Burlington Development Review Board

Development Review Board

Wednesday, March 25, 2026, 5:00 PM

To: Development Review Board
From: Mary O'Neil, AICP, Principal Planner
Date: March 25, 2026
RE: ZP-26-54; 49 Henderson Terrace

A100

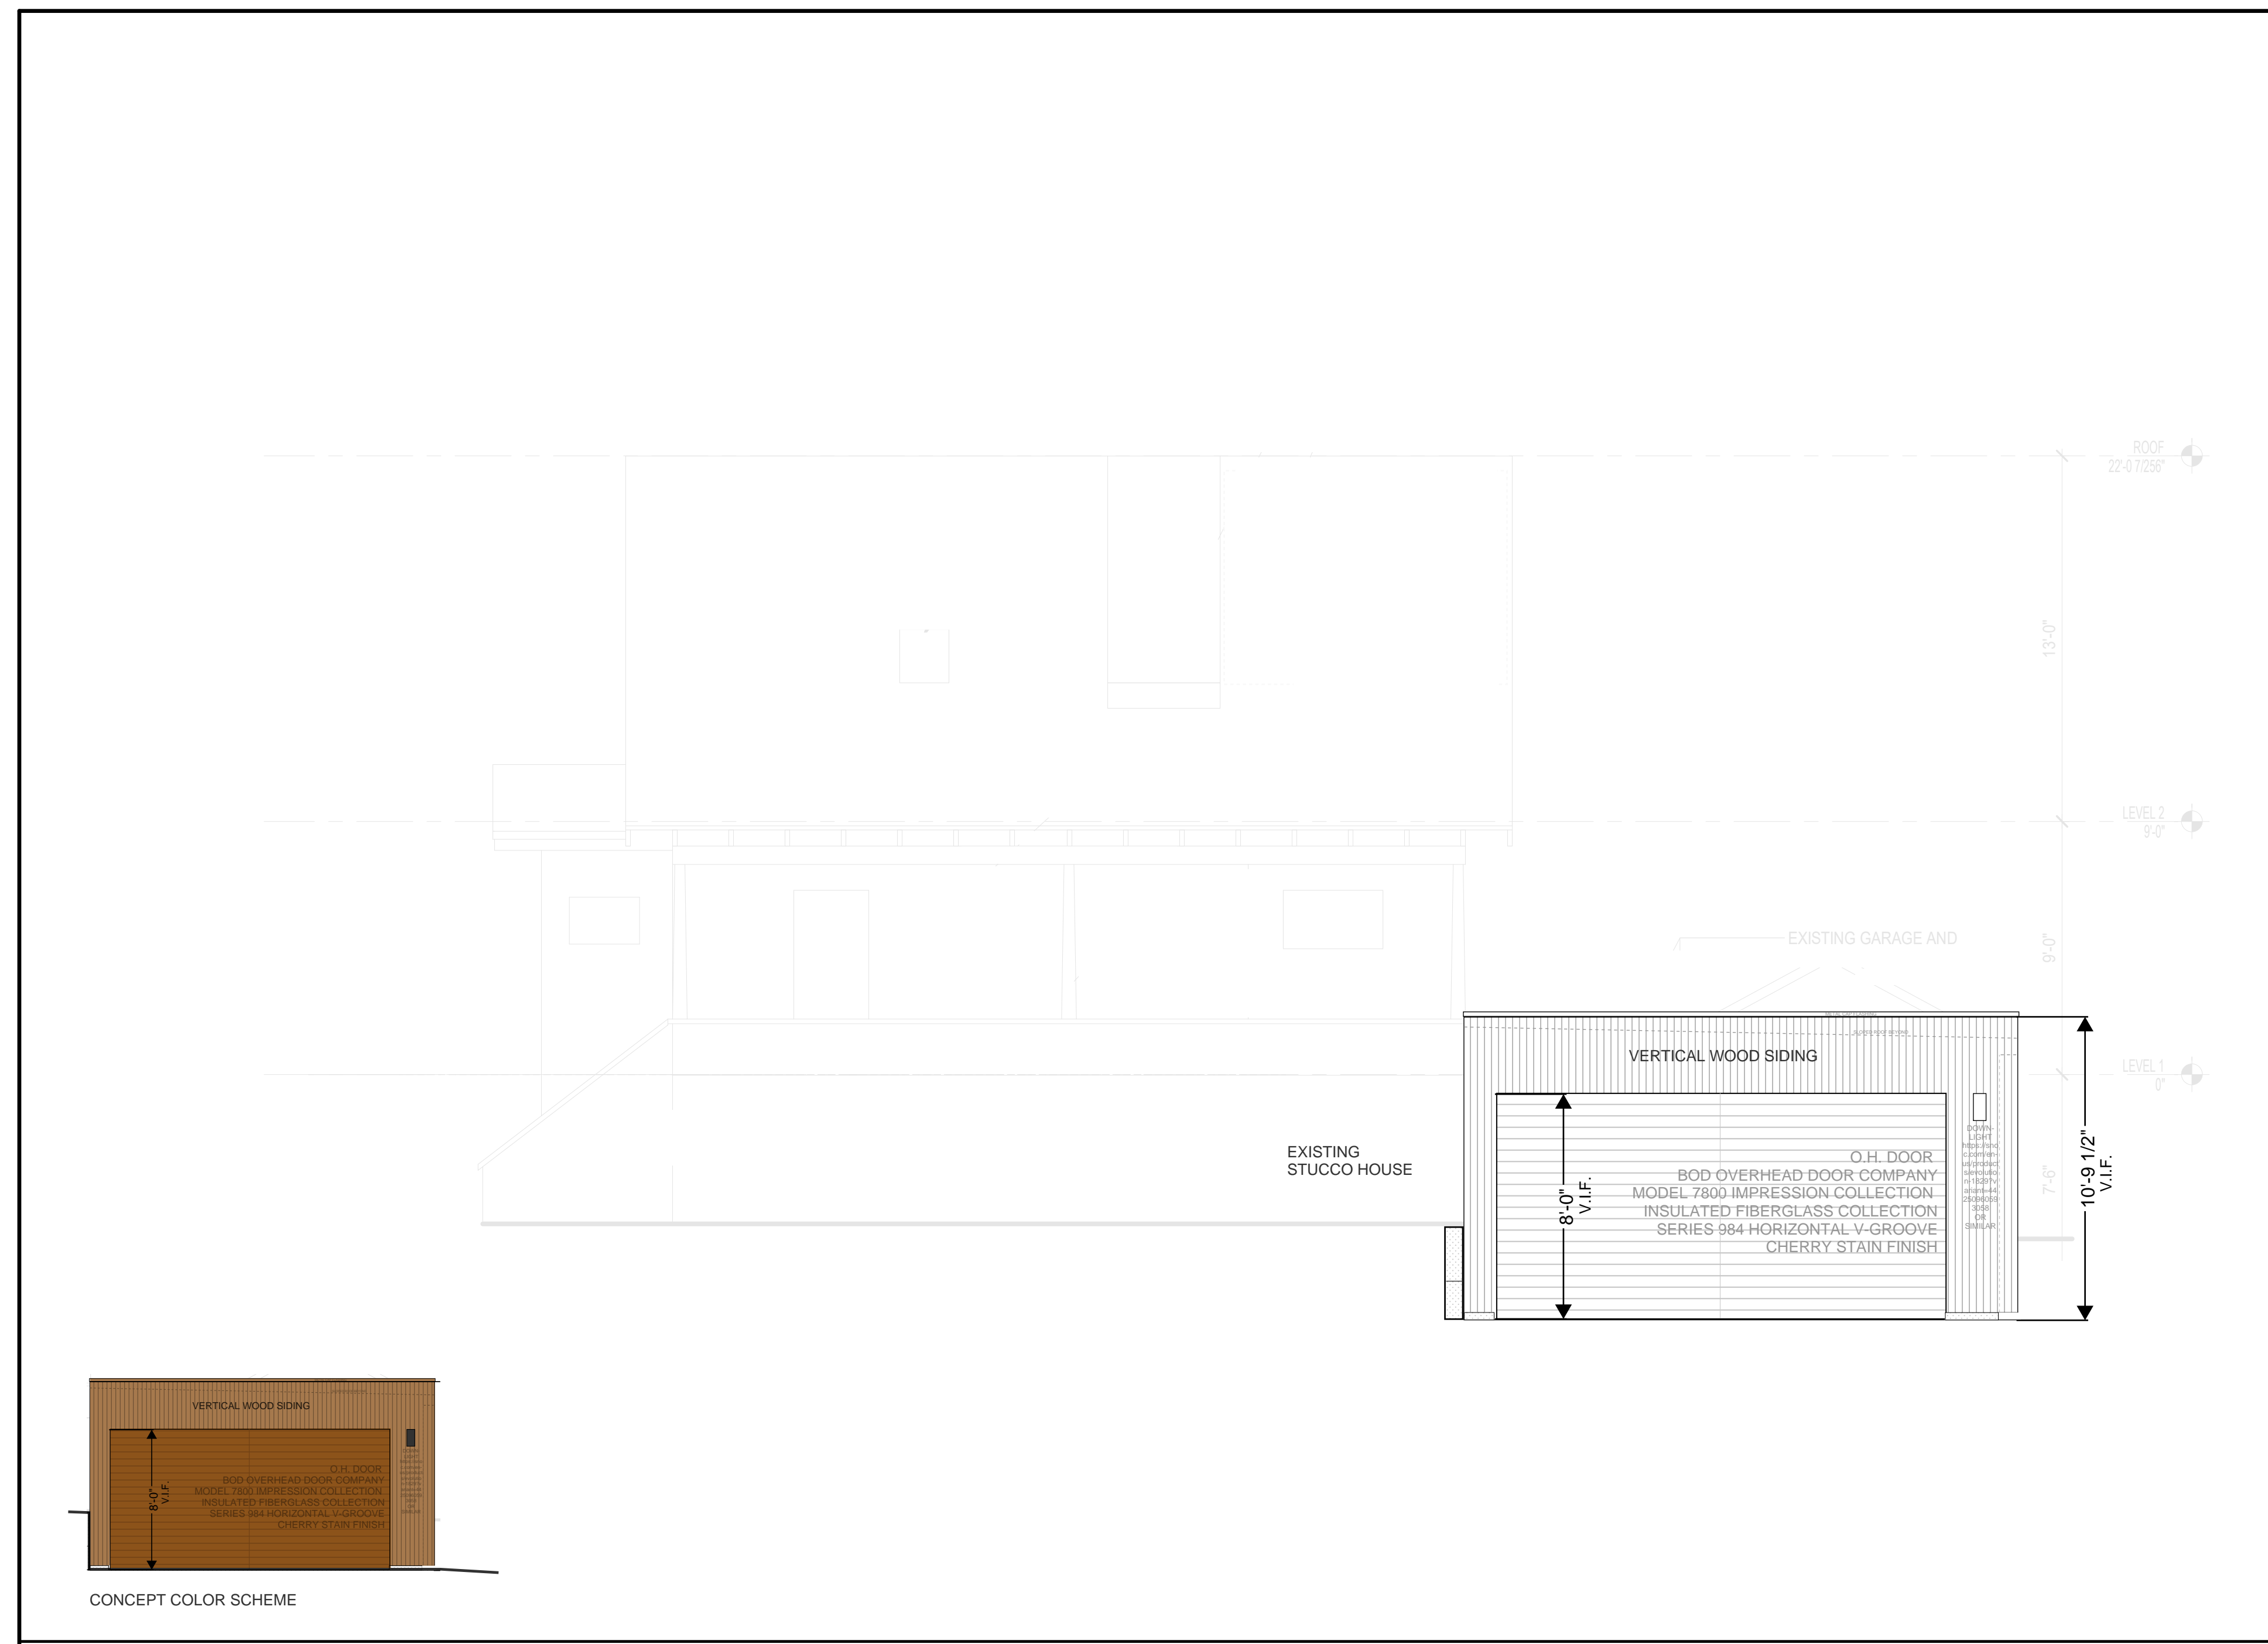
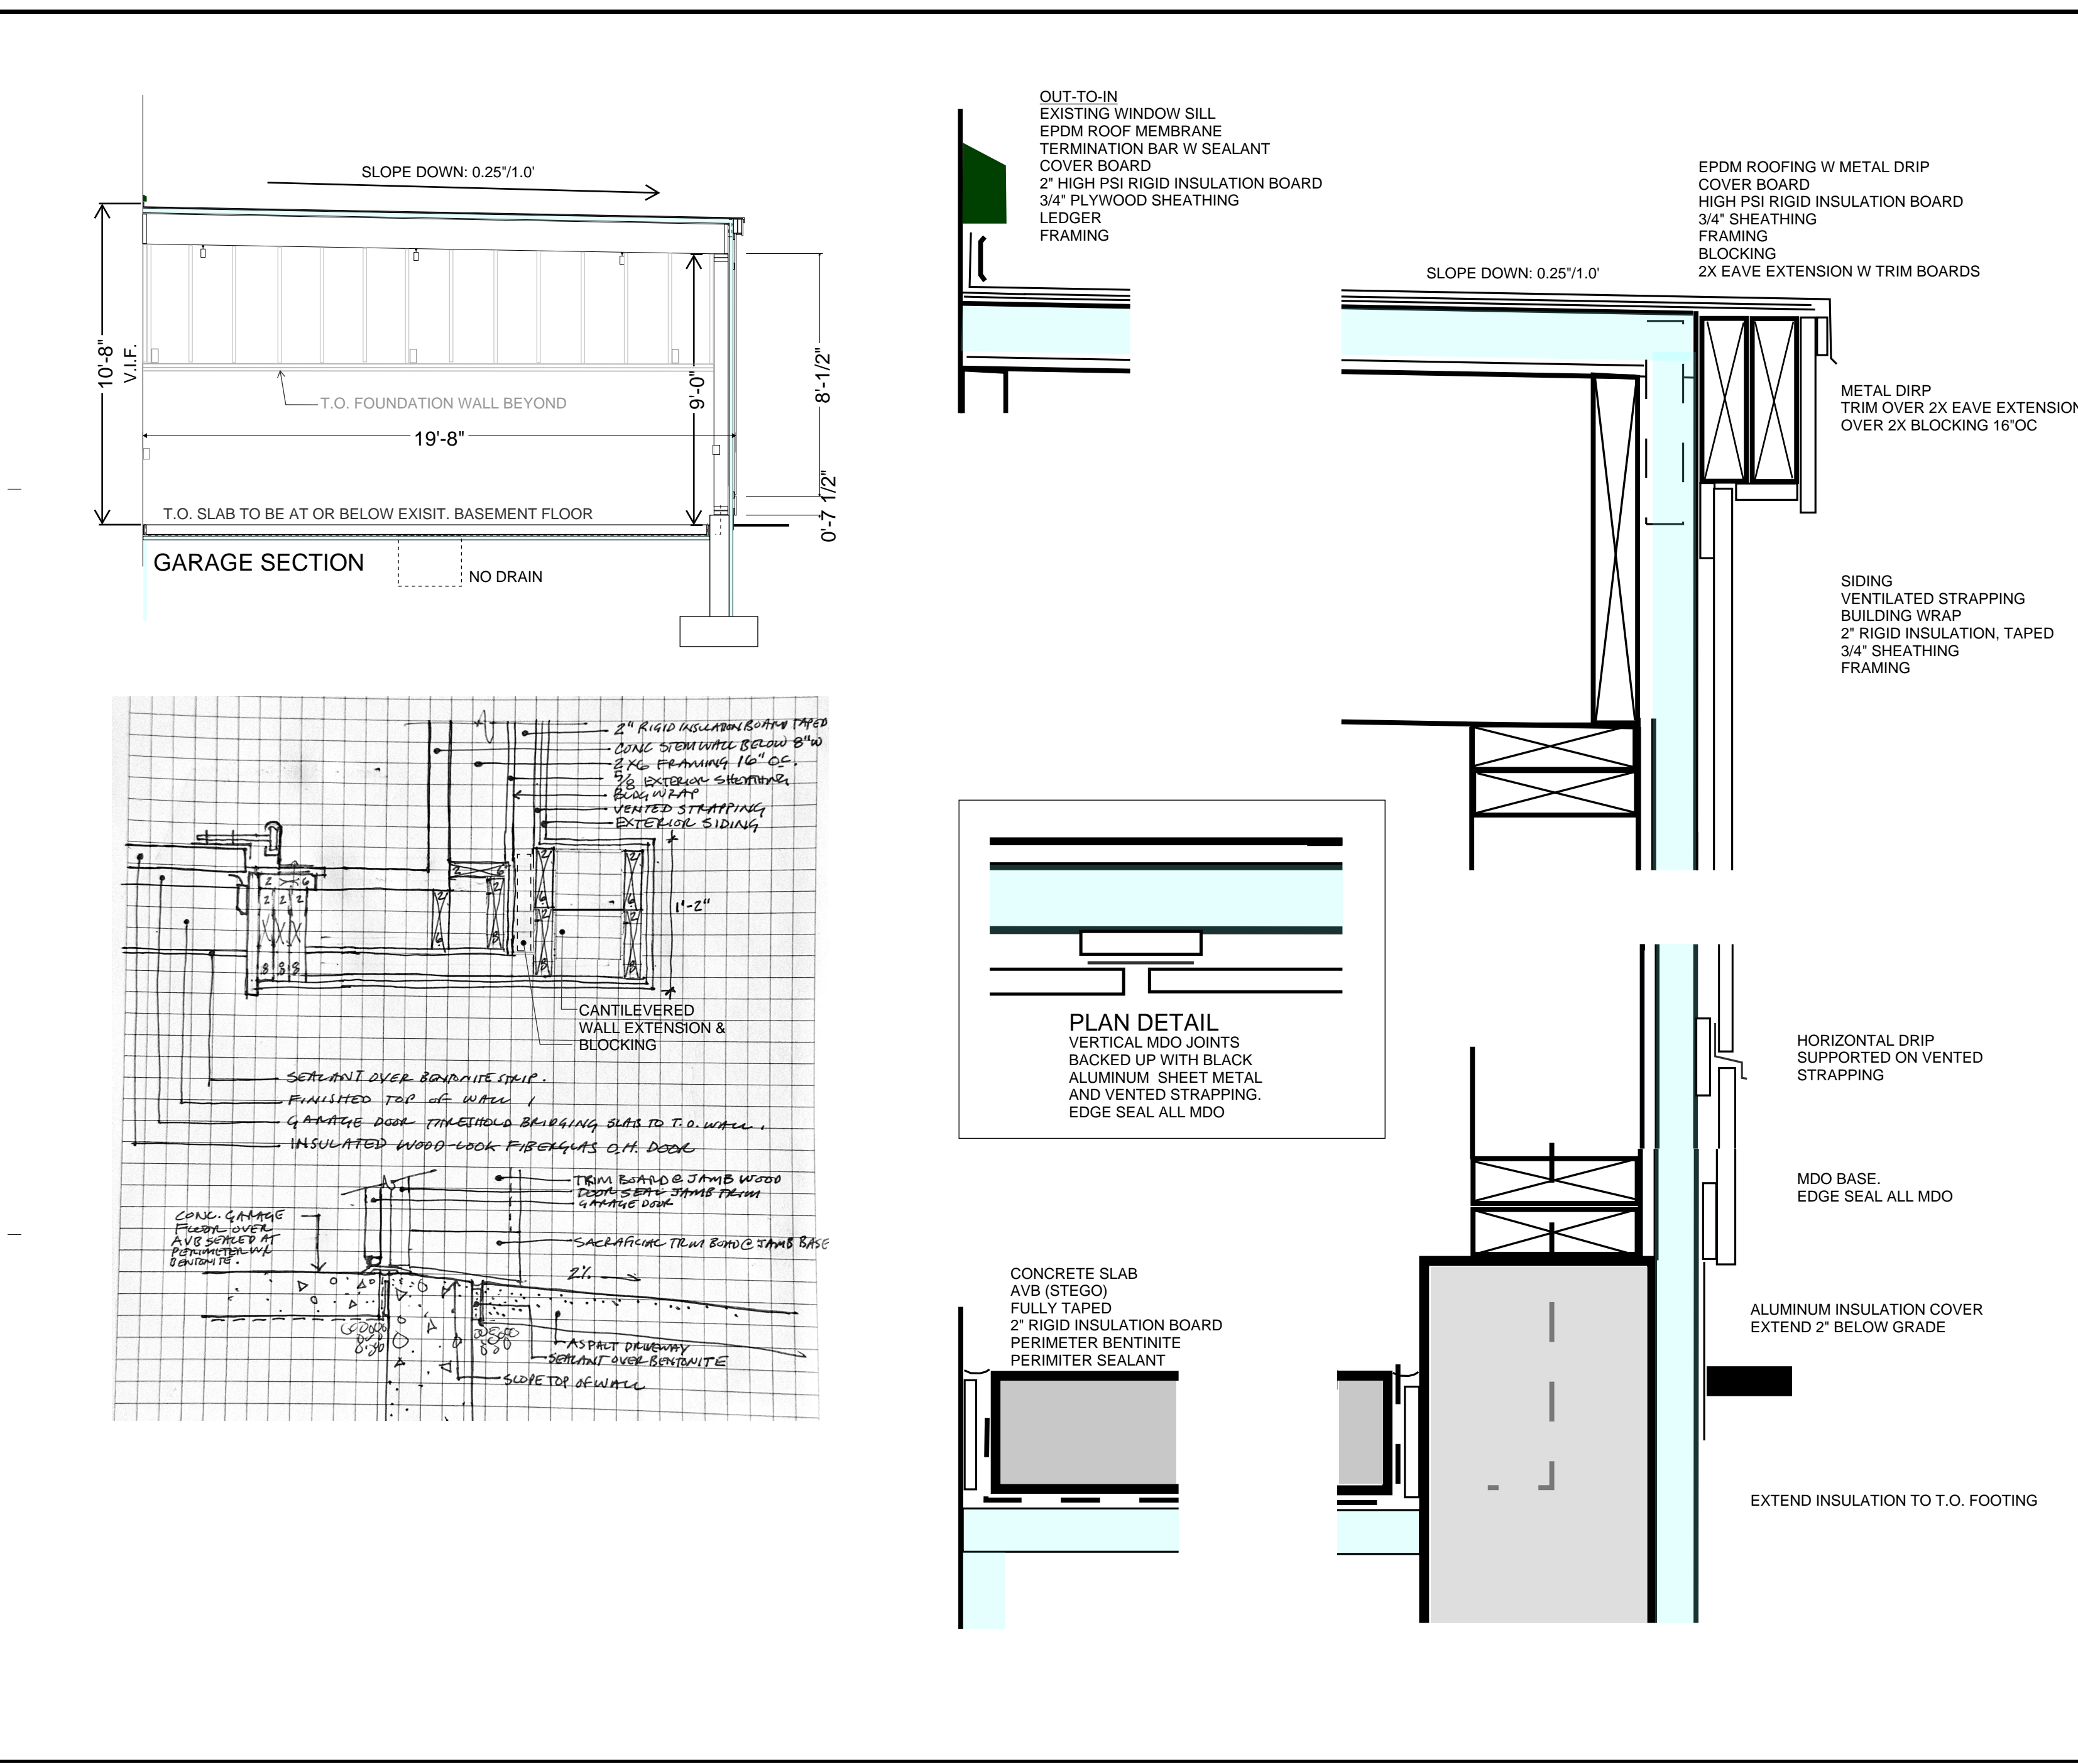
A diverter strip is proposed on the roof above the westerly pedestrian door. See Plans A100 and A200. **Affirmative finding.**

The application shall be revised to limit garage doors or no more than 10' in width.
Affirmative finding as conditioned.

1. The application shall be revised to limit garage doors or no more than 10' in width.
